DATE: 05.15.2019
TO: ProTrak
FROM: Mitesh Baxi
Traffic Engineering

■ **HENDRICK MAZDA OF WILMINGTON [TRC Plan Review]**

↻ Initial Review Note ↻

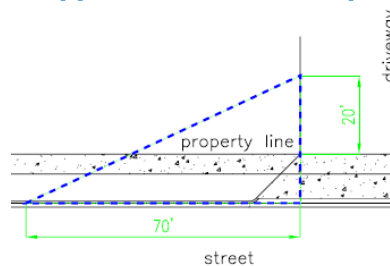
1. This segment of Market St is a major thoroughfare [Chap VII (C) (2) of CofW Tech Stds]. Driveways for lots along major thoroughfares must be at least 75’ offset from property lines measured at the curb line. [Chap VII (C) (2) (c) (2) of CofW Tech Stds]. A variance may be required for this project.
2. Maximum allowed driveways along major thoroughfares is 1 for 600 of frontage plus 1 every 300 feet additional or portion thereof as measured at the property line. [Chap VII (C) (2) (b) of CofW Tech Stds] A variance may be required for this project.
3. Wheelchair ramps shall be installed at the street type driveways, in accordance with ADA/City/NCDOT standards.

Any ramps at the existing street type driveways, shall be retrofitted with flexible surface-applied detectable warning mats [Chapter II (E) (6) of CofWTSSM] [NCDOT]
